Modification Changes
- Addition of louvers to podium of the mezzanine level and level 1
- Airlock reconfiguration

Project
WATERLOO METRO QUARTER DEVELOPMENT

Sheet title
General Arrangement Plan
Level 1 Plan

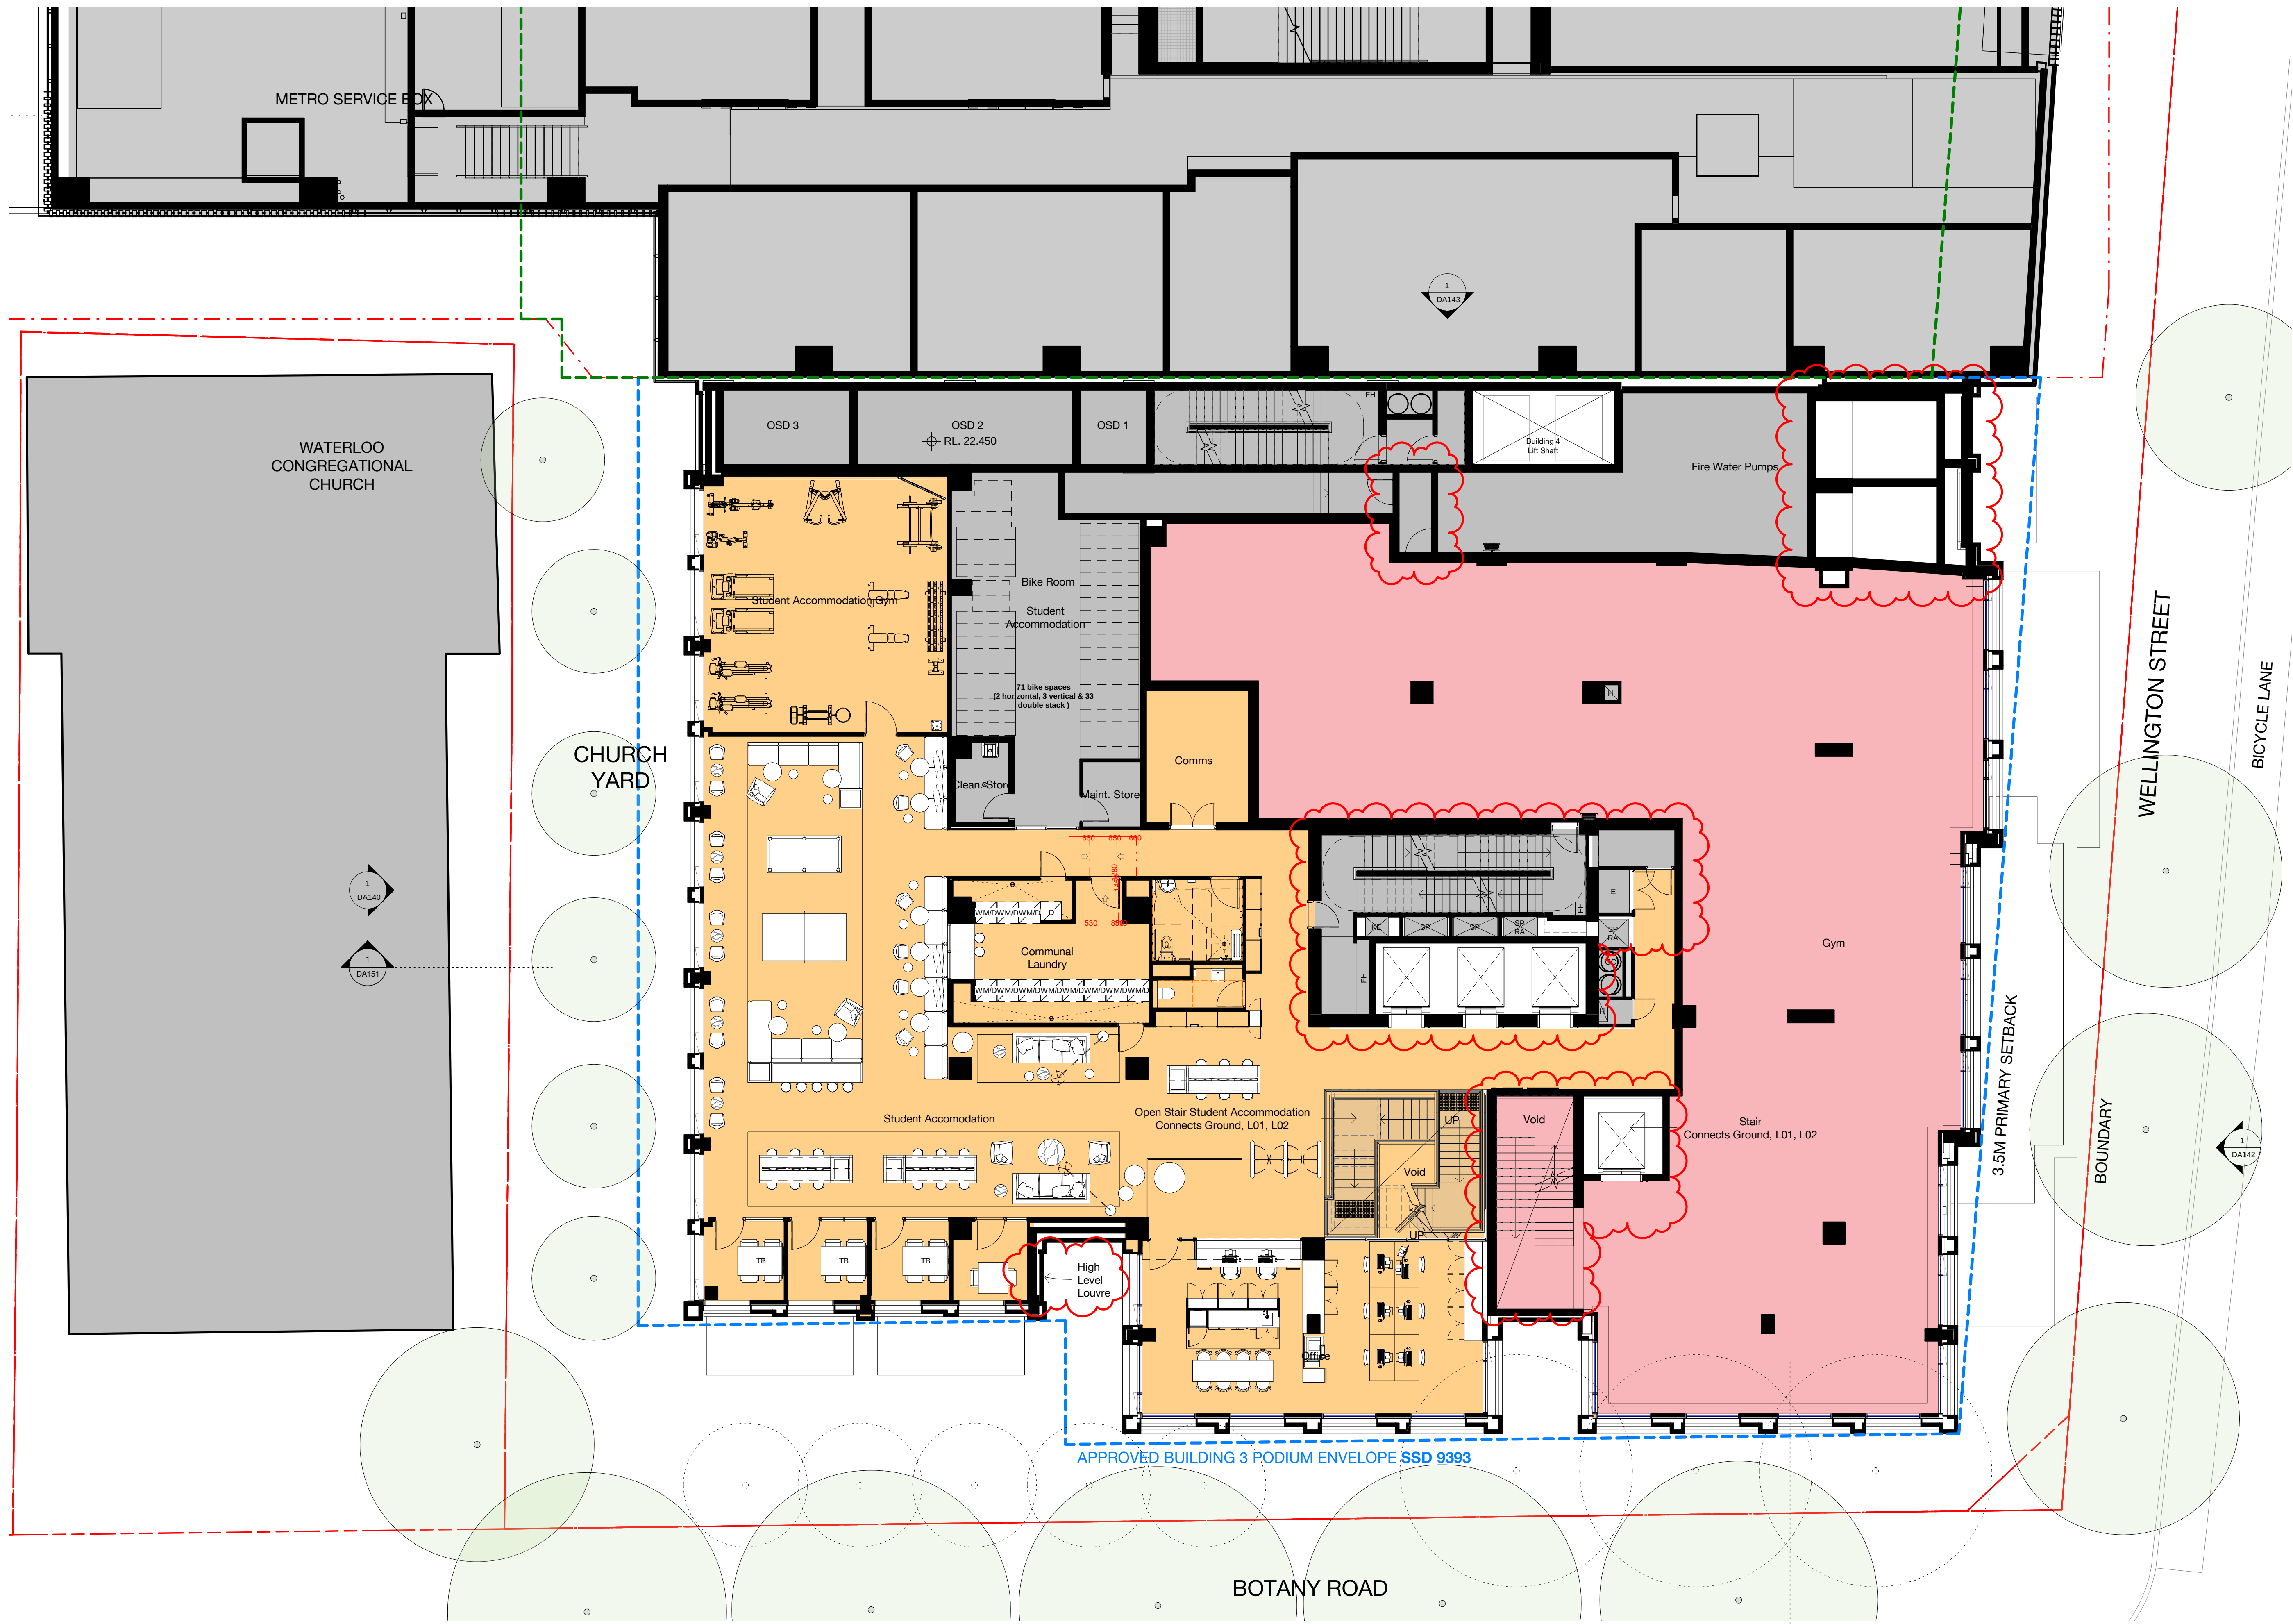
- Modification Changes
- Student Accommodation - reconfiguration to the core and services
 - Gym - lift and stair reconfiguration
 - Addition of louvers to podium of the mezzanine level and level 1
 - Airlock reconfiguration

Sheet title
General Arrangement Plan
Level 2 Plan

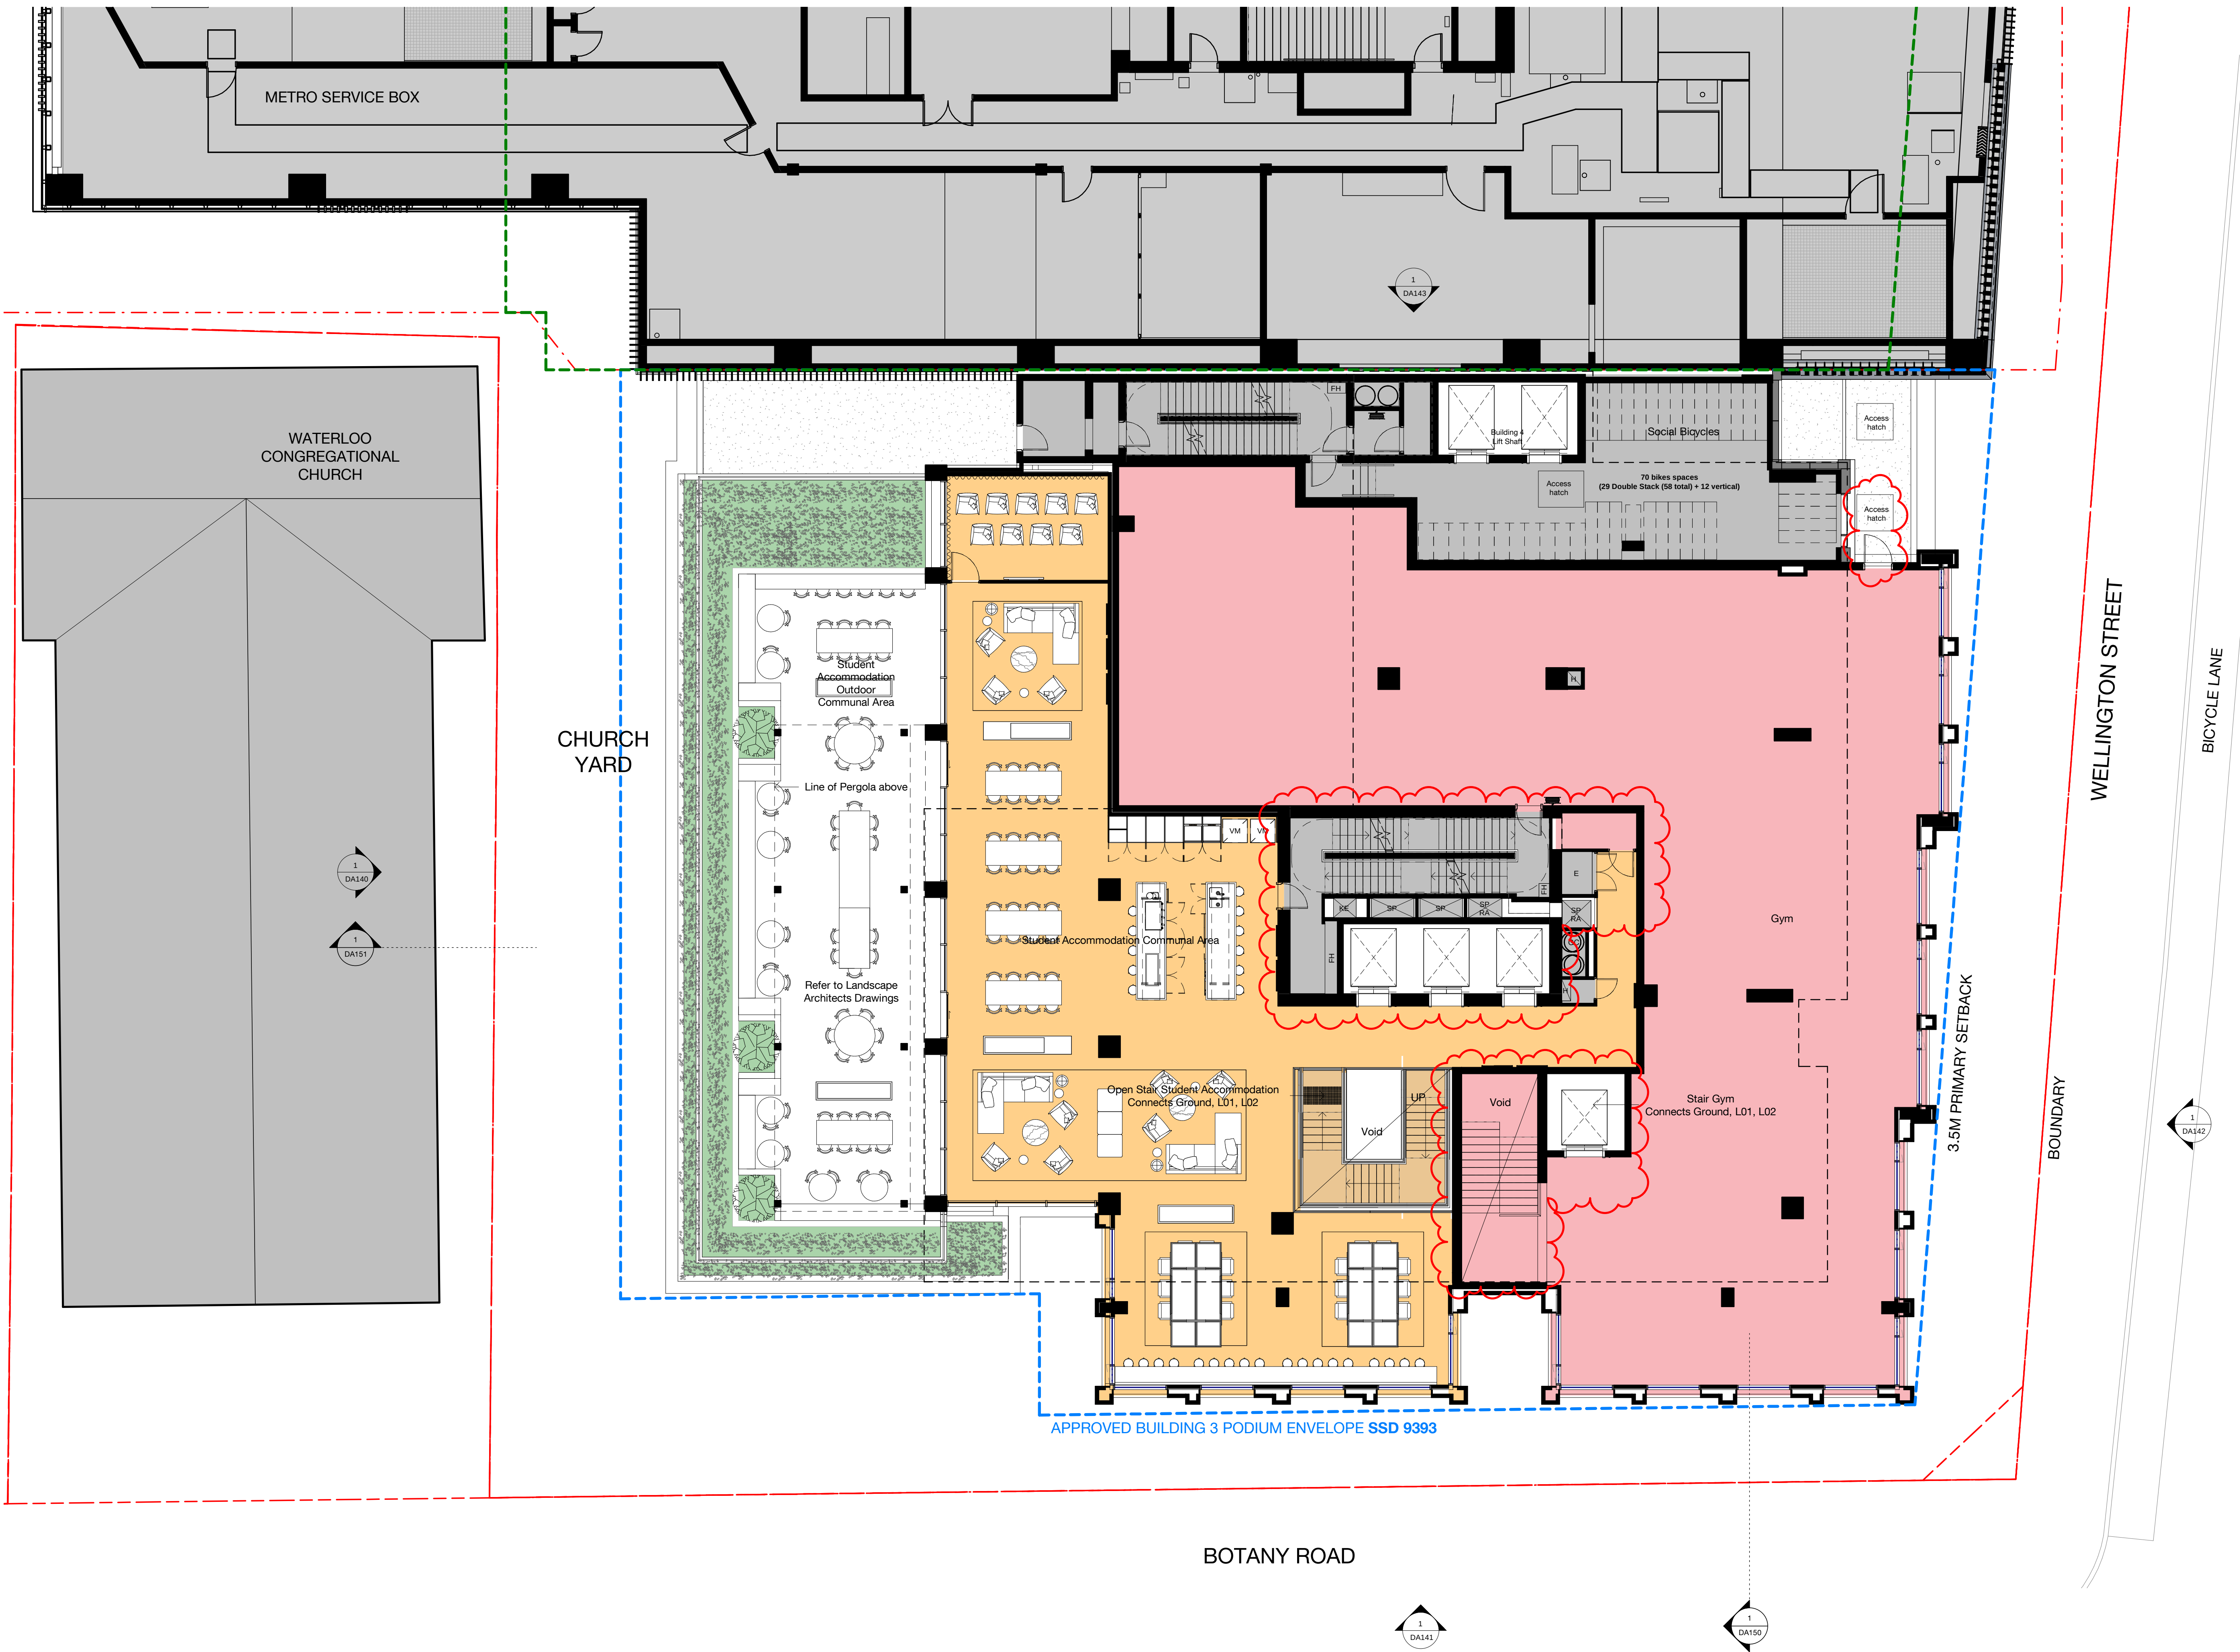
- Modification Changes
- Student Accommodation - reconfiguration to the core and services
 - Gym - lift and stair reconfiguration
 - Addition of access hatch
 - Additional services door to podium roof

Sheet title
General Arrangement Plan
Level 3-5 Plan

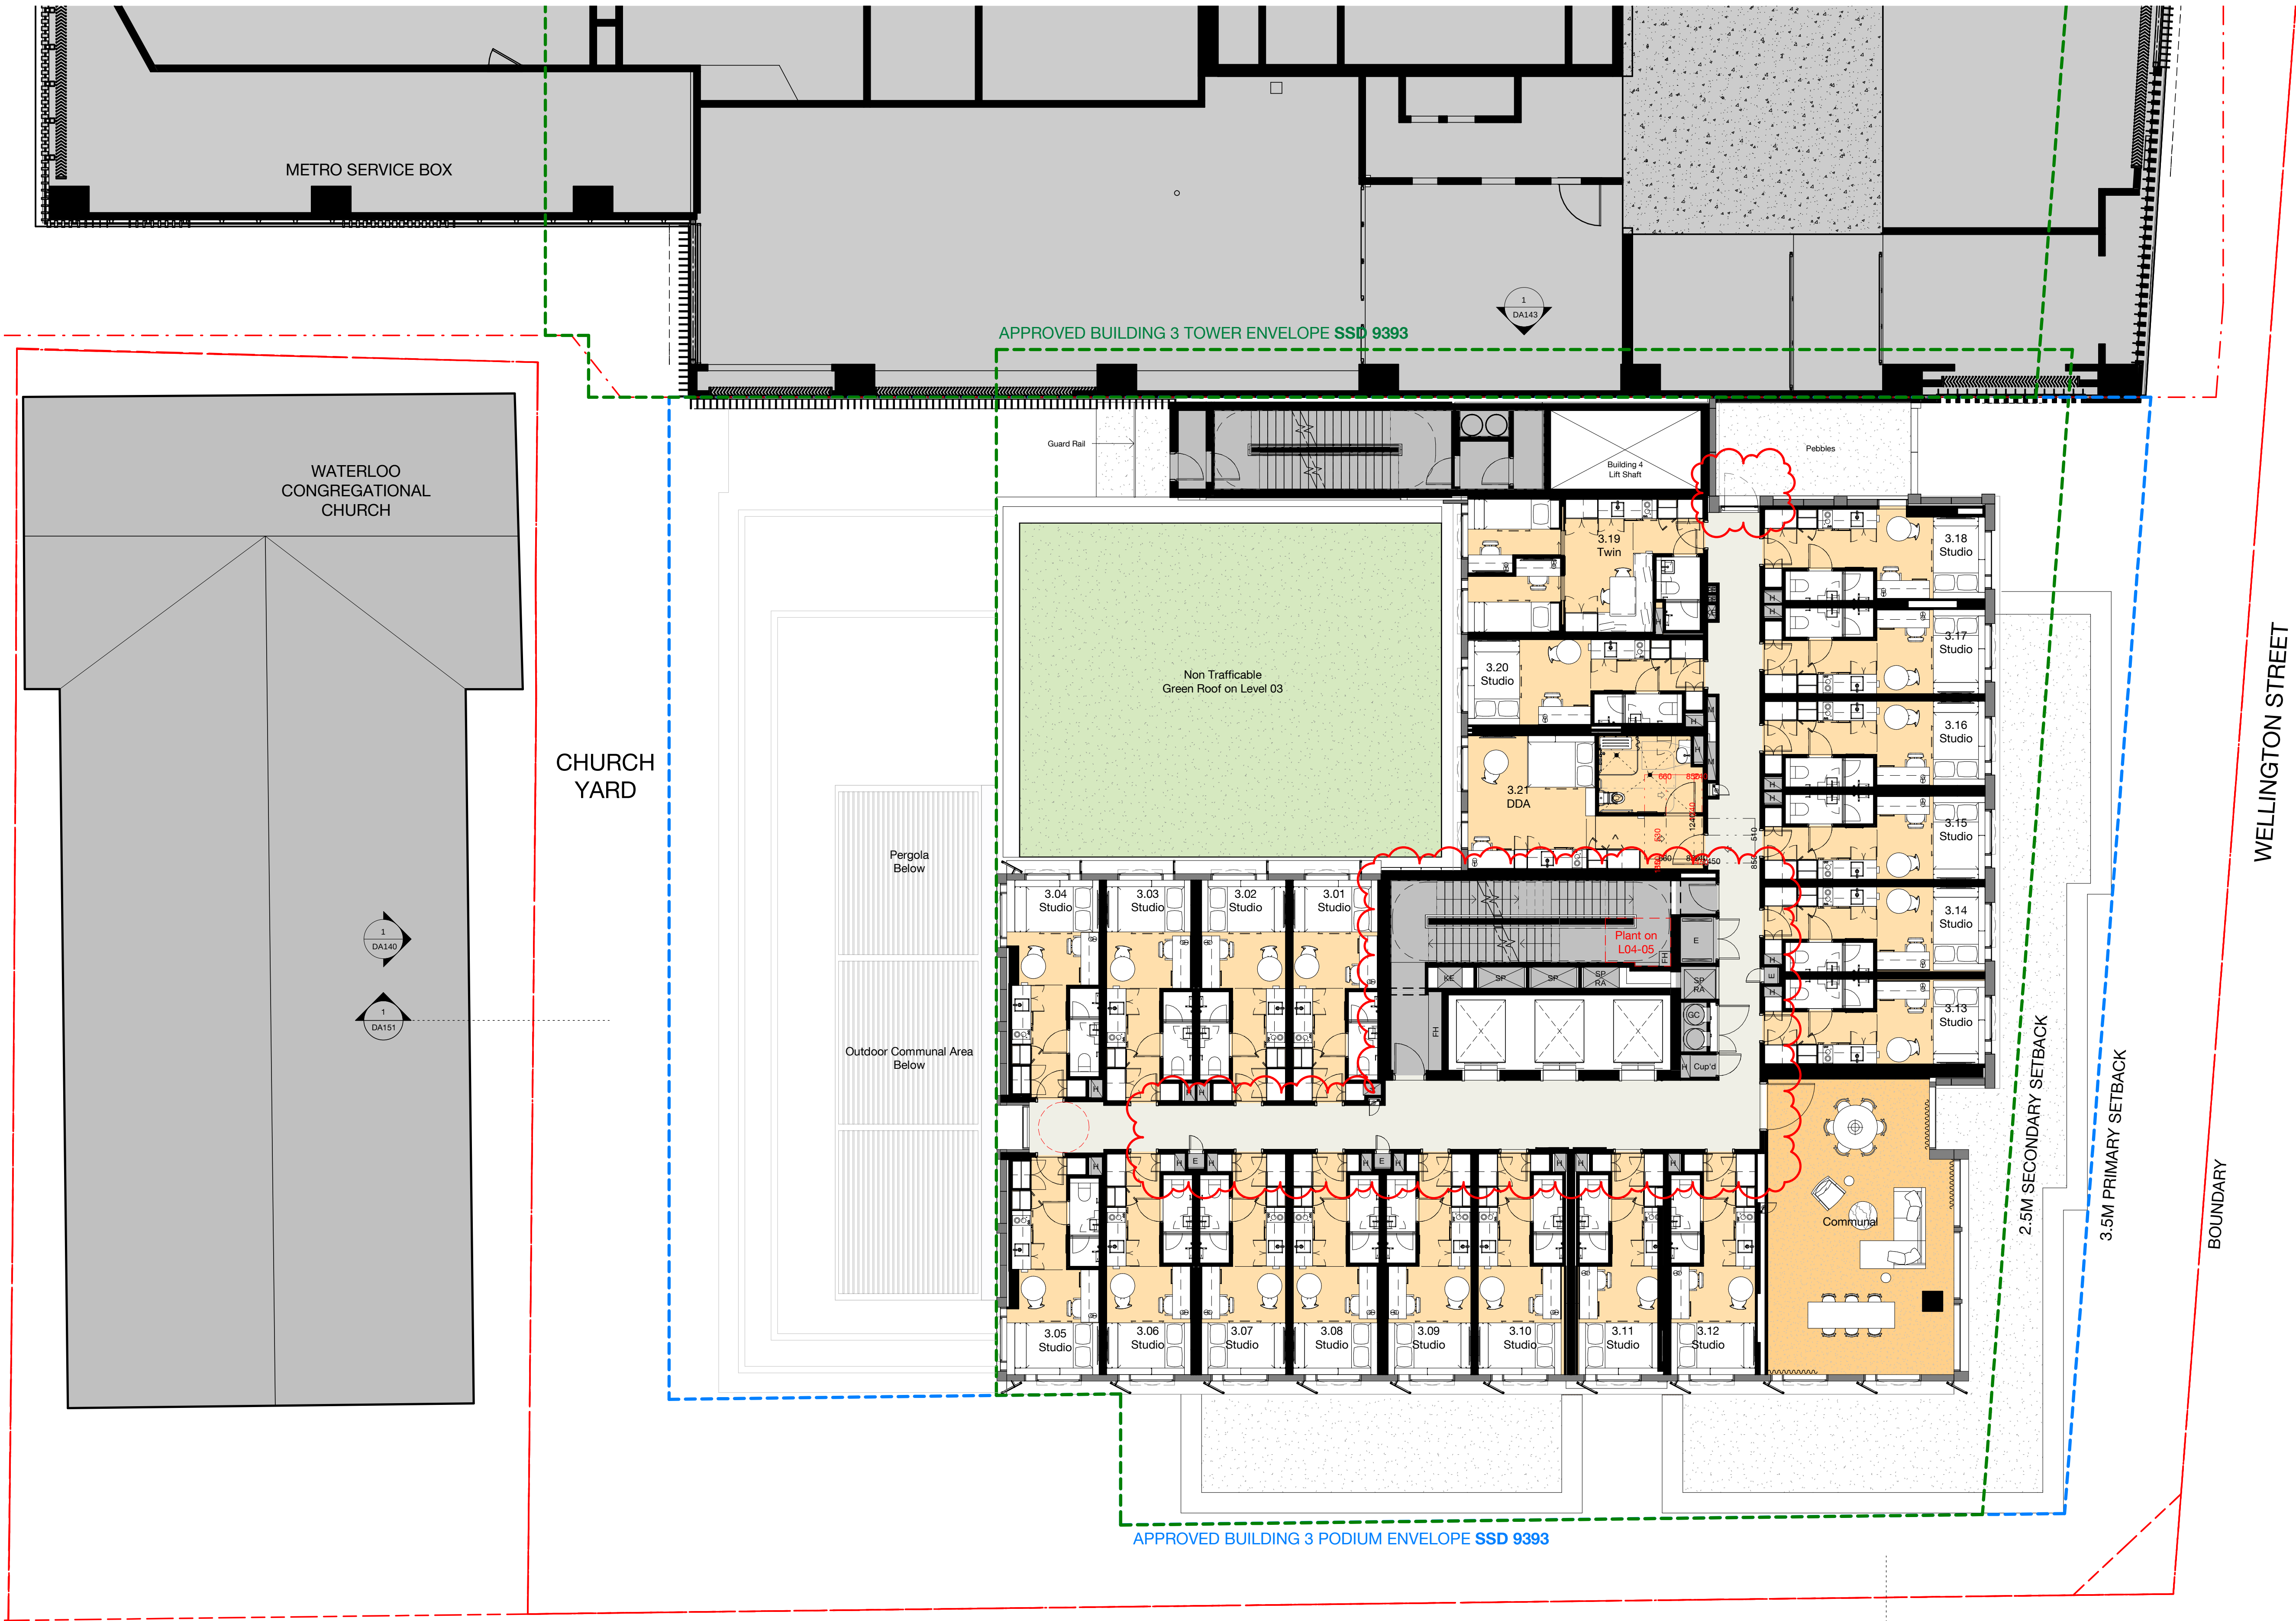
- Modification Changes
- Student Accommodation - reconfiguration to the core and services
 - Additional services door to podium roof
 - Additional services risers
